CHATHAM COUNTY PURCHASING DEPARTMENT
ADDENDUM NO. 1 TO BID 20-0029-7

FOR: Sharon Park Landfill Access Road Improvements

SHARON PARK LANDFILL ACCESS ROAD IMPROVEMENTS PROJECT

REVISED CONCRETE PAVING DETAIL

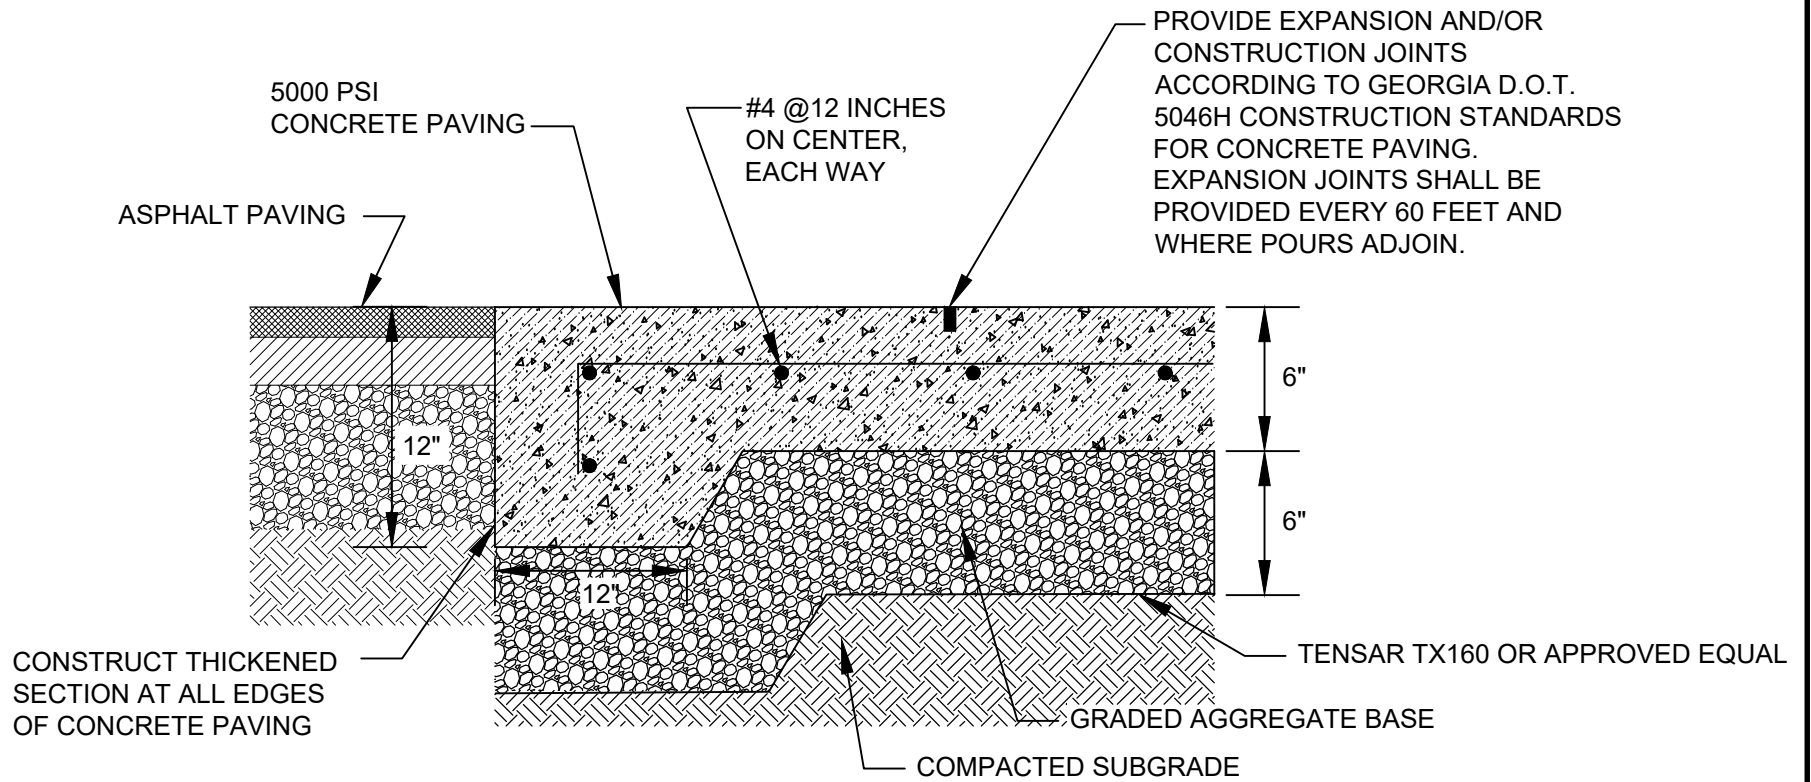
2. **QUESTION:** Is the quantity correct for the concrete pavement, line item 7?
RESPONSE: The line item quantity has been revised to show 550 SY on the enclosed revised Bid Schedule. The County has requested concrete for the entire 30 feet x 160 feet area. The concrete has also been revised to a 5,000 psi concrete with rebar reinforcing. See the enclosed detail.

RESPONSE: The concrete container pad will now be 30 feet wide by 160 feet long. Refer to the revised concrete paving detail enclosed.
